LEVEL 3 & 4 DEVELOPMENT REVIEW APPLICATION

Level 4 Review

Stuart Property

Thornhill Road

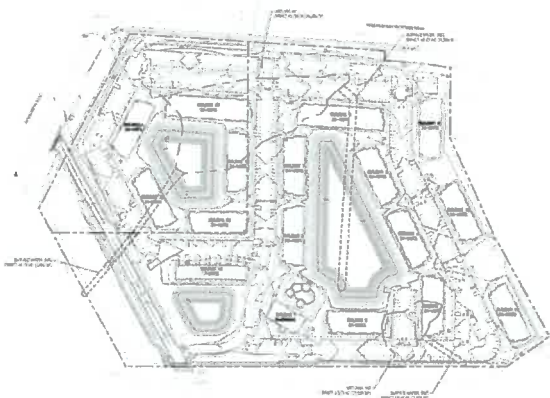
Bubble Plan - The bubble plan shows a proposed Residential-High (RH) designation, but the application states that the request is for Residential-Medium (RM). Please clarify.

RESPONSE: The application was in error. The proposed bubble plan is correct as shown.
